Advice Note 02

Spatial Planning Framework Commission

Job number:	SB514	
Job title:	PJ Browns Bolney Access from A23	
LPA name:	Mid Sussex Council	LPA Ref: EF/18/0446
To:	Marius Pieters	cc:
Topic:	Transport Statement and Travel Plan review	
	Prepared:	Checked/Approved
Name:	Harry Robinson	Terry Dale
Date:	29/08/2024	10/09/2024

Figure 2. Location of site access

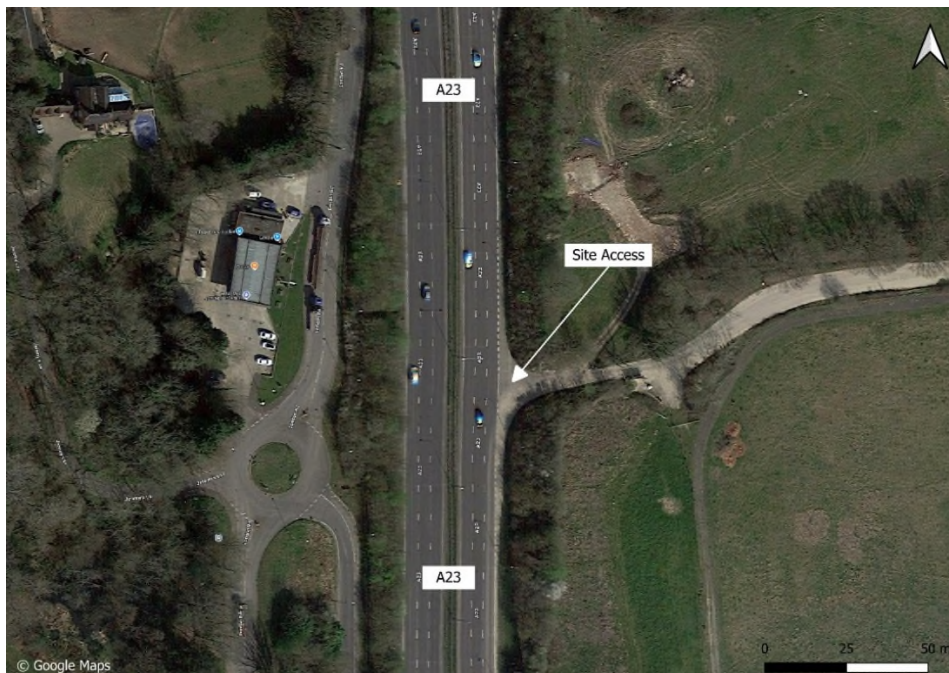
- 6 As shown in **Figure 2**, the appeal site gains access via a priority junction with the A23 that operates as left in/left out. This access has existed at this location for several years; therefore, its geometric layout predates the current highway design standards outlined in the Design Manual for Roads and Bridges (DMRB), which was comprehensively reviewed in 2019. At the time of its original formation, likely coinciding with improvements to the A23, the junction would have been categorised as a 'Direct Access', and the prevailing DMRB design standard (TD41/95) should have applied. Nonetheless, the junction lacks a traffic island, hatching, or bollards, all of which are typical features of a Direct Access arrangement consistent with TD41/95.

- 7 Furthermore, the access road itself is insufficiently wide enough to accommodate two-way movements; hence, a vehicle exiting the land may obstruct access and may cause an incoming vehicle to overhang into the main carriageway if it is of a length greater than 10m.

- 8 Commensurate with the speed limit on the A23, the visibility splay to the south of the access (left) should be 4.5m (minimum X) x 295m (Y); this splay is apparently unachievable however, potentially due to the overgrowth of vegetation in the verge. Visibility to the north (right) of the access can be achieved from a minimum 4.5m setback; this is 4.5m x 295m and 4.5m x Tan.

Figure 4. PIC Data 2002 – 2022

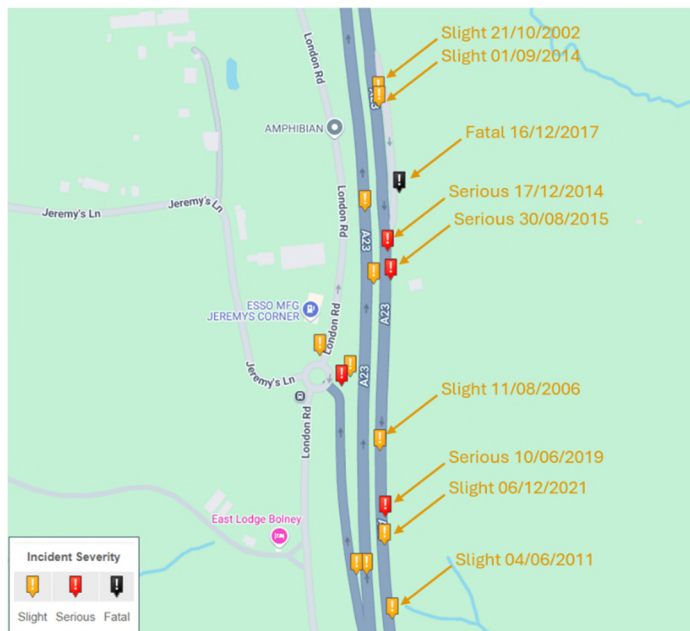
- 30 As discussed, the A23 is subject to a 70-mph speed limit; hence, the SSD requirement is 295m (ref: DMRB CD109). Within 295m of the site access, therefore, we noted nine PIC on the southbound carriageway of the A23.

- 31 Four of the PIC are located to the south of the access, one of which was categorised as serious; two are located to the north of the layby and one, a fatality, is located within the layby. The remaining two are located between the layby exit and the appeal site access; these are categorised as serious and occurred in 2014 and 2015.

- 32 The spread of PIC on this section of road suggests that there is no specific trends or clusters, albeit the JSJV notes that standing water was cited as a contributory factor in two of the nine collisions. Equally, that none of the PIC recorded over an extended period are directly adjacent to or associated with the access suggests that presence of the access in itself does not generate a road safety issues.
